Access Compliance Report

Public Rights-of-Way

(Curb Ramps)

Intersection ID: 10040974	Main Street: WALSH_BV	Cross Street: N/A	Location: E
ADA ID: D4AF8A0A39FB	Ramp Type: PerpDiag	Initial Pass/Fail: Fail	Overall Compliance: No
			Severity Score: 58.75

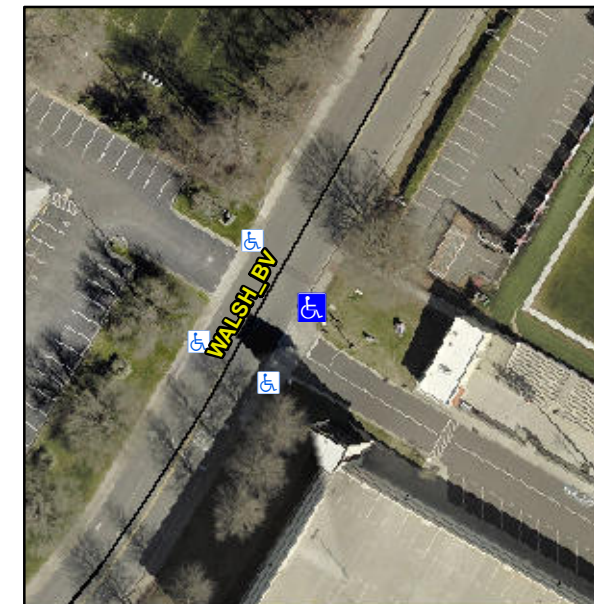
Not Found, R304.5.1, R304.2.2, R304.5.3

Compliance	Description	Data	Compliance	Description	Data
N/A	Ramp Length (in)	60.0	No	Ramp Slope (%)	12.9
No	Ramp Width (in)	43.0	No	Ramp XSlope (%)	7.9
N/A	Flare Type LT	N/A	N/A	Flare Type RT	N/A
N/A	Flare Slope LT (%)	N/A	N/A	Flare Slope RT (%)	N/A
N/A	Flare Traversable LT?	N/A	N/A	Flare Traversable RT?	N/A
N/A	Landing Length (in)	N/A	N/A	DWS Provided?	N/A
N/A	Landing Width (in)	N/A	N/A	DWS Contrast?	N/A
N/A	Landing Slope (%)	N/A	N/A	DWS Length (in)	N/A
N/A	Landing X Slope (%)	N/A	N/A	DWS Full Width?	N/A
N/A	Landing Curb? (Y/N)	N/A	N/A	DWS Offset (in)	N/A
N/A	Shared Landing?	N/A			
N/A	Gutter Ponding?	N/A	N/A	Gutter Slope (%)	N/A
N/A	Gutter Lip Ht (in)	N/A	N/A	Gutter X Slope (%)	N/A
N/A	Painted X Walk1?	No	N/A	Painted X Walk2?	No
	X Walk 1 Direction	To NW		X Walk 2 Direction	To SW
N/A	X Walk 1 Width (in)	N/A	N/A	X Walk 2 Width (in)	N/A
	X Walk 1 Slope (%)	4.8		X Walk 2 Slope (%)	3.5
	X Walk 1 X Slope (%)	2.3		X Walk 2 X Slope (%)	6.3

Remove & Replace Curb Ramp With Two New Directional Ramps or Equivalent.
